MITSUBISHI MOTOR SALES OF AMERICA, Inc.

TECHNICAL SERVICE BULLETIN

LIMITED SLIP DIFFERENTIAL CASE MEASUREMENTS – SERVICE MANUAL UPDATE

NO. TSB-89-03-001

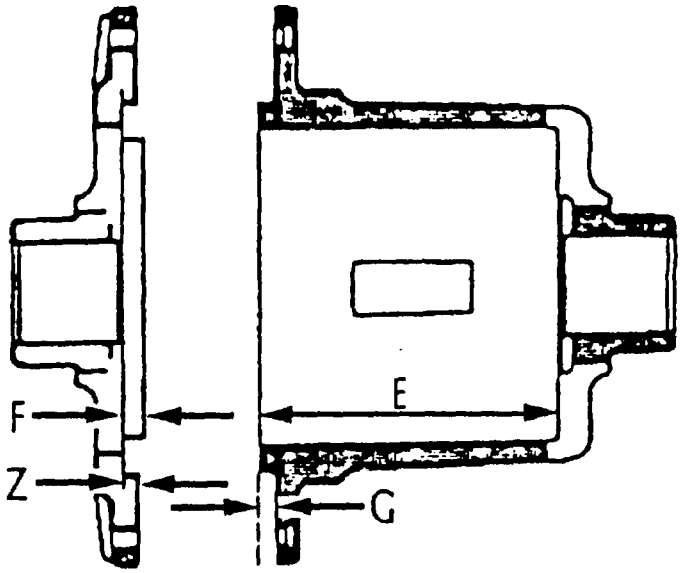
The limited slip differential used in V6 Monteros has a raised surface not shown in the Service Manual. This raised surface (shown as measurement "F" in the illustration below) changes the formula used to find case clearance "D" on page 3-40 of the Montero Service Manual. Use the following formula when figuring case clearance for the limited slip differential on a V6 Montero.

D = E + Z - F - G
